RE: SEP-22-003 Determination of Significance for the Logan's Landing proposal

**DETERMINATION OF SIGNIFICANCE
AND REQUEST FOR COMMENTS ON SCOPE OF EIS**

Logan's Landing – PRE-21-008

PRE-21-008 site plan.pdf

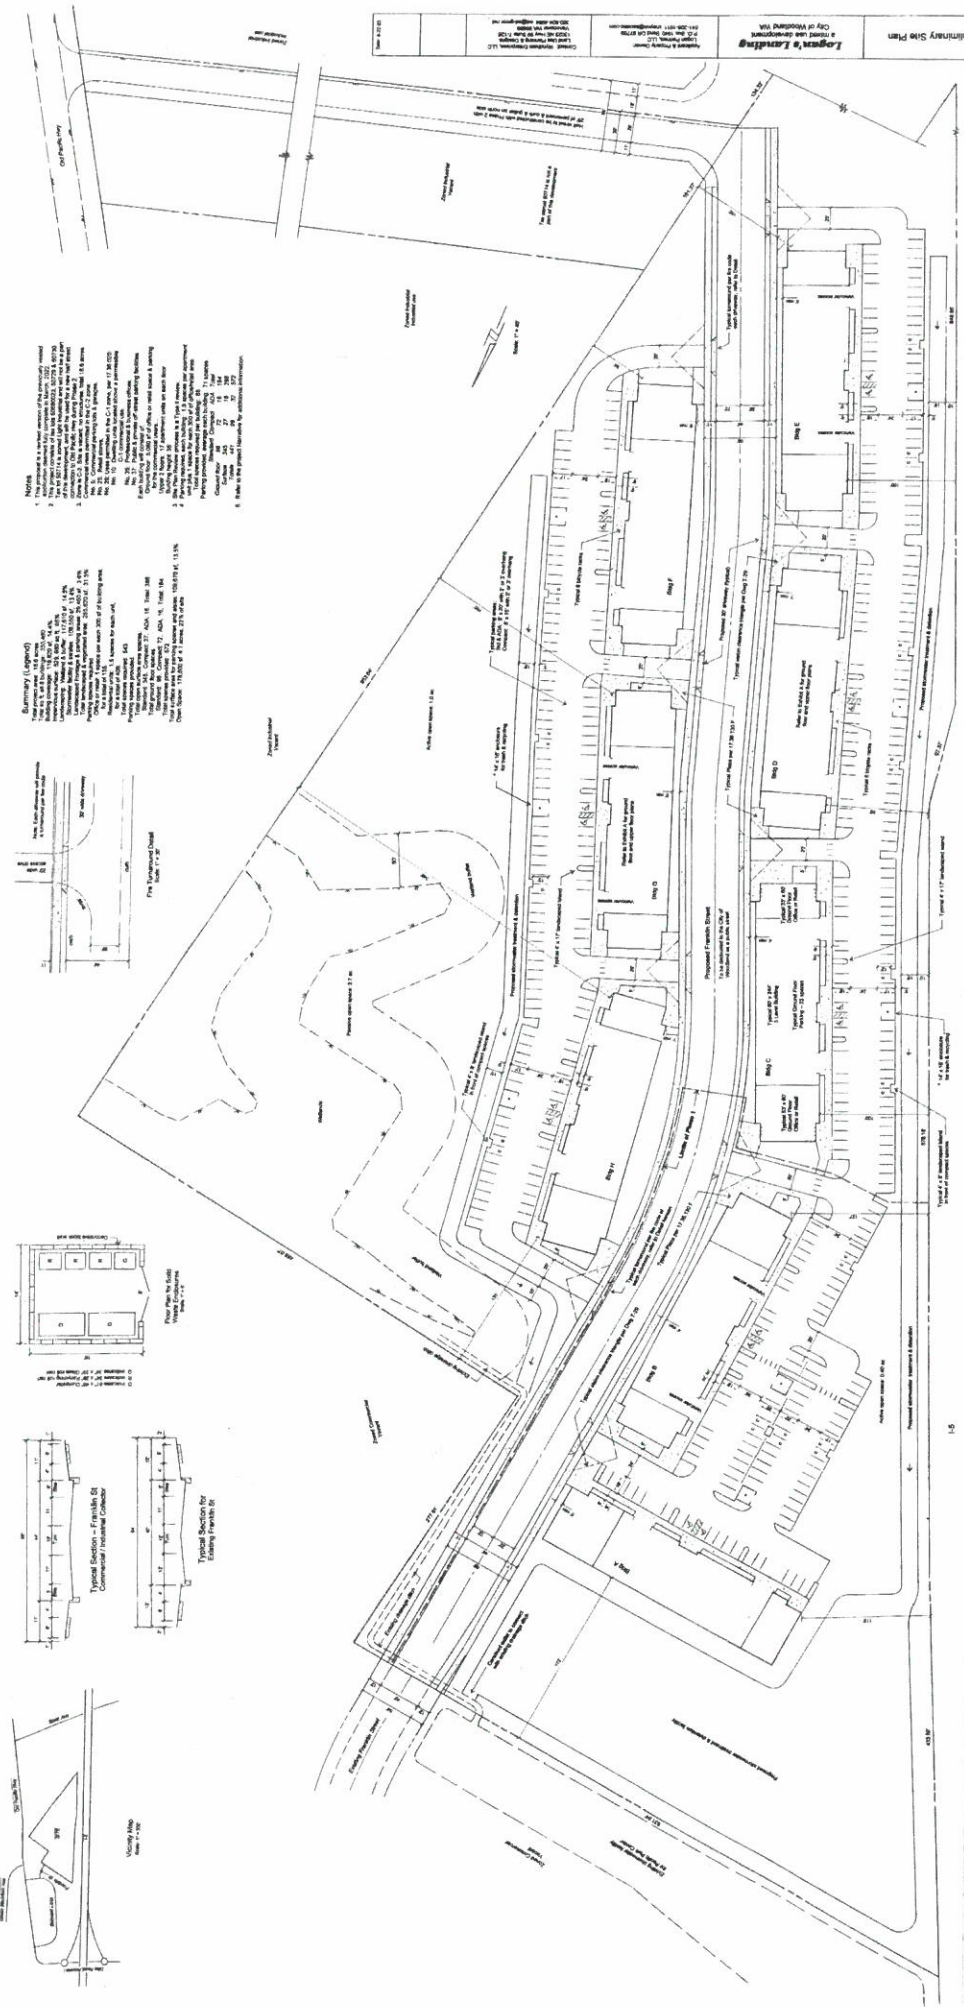
Michael Jackson 3608874609
mike.jackson@clarkfr.org Aggregate gross building size in the development exceeds 124,000 SF, requiring a second point of access. Franklin should be extended to provide secondary access to the development.

Michael Jackson 3608874609
mike.jackson@clarkfr.org Fire hydrants shall be provided along all required fire apparatus access roads in quantities and with spacing in accordance with the Fire Code. Hydrants shall be supplied on looped systems with a minimum water main size of 8" for all commercial areas. (Fire Code Appendix B and C for hydrant numbers based on flow and locations / spacing.)

Michael Jackson 3608874609
mike.jackson@clarkfr.org Access for buildings exceeding 30' in height must include aerial apparatus access on one side with a clear width of 26' that is located between 15' and 30' from the building.
